Notice regarding the change of the A8L series specifications

This PCN is intended for use exclusively in EUROPE, Middle East and Africa.

- Rocker Switch A8L series
- < Refer to the " [Details of applicable model] " . >

Examples of products

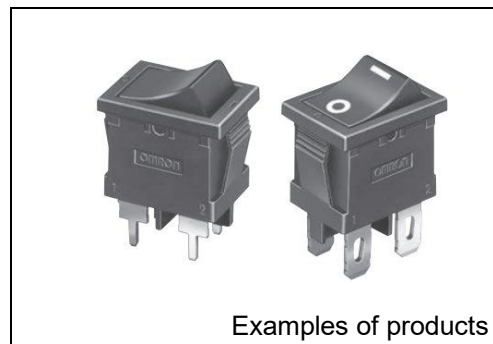
Before the change	After the change
<p>Change specification items Specified temperature range : - 20°C ~ - 55°C Specified humid range : 45%RH ~ 85%RH Shock value : 500m/s²</p>	<p>We will expand the specifications according to customer requests.</p> <p>Change specification items Specified temperature range : -20°C ~ -85°C Specified humid range : below 85%RH Shock value : 1000m/s²</p>
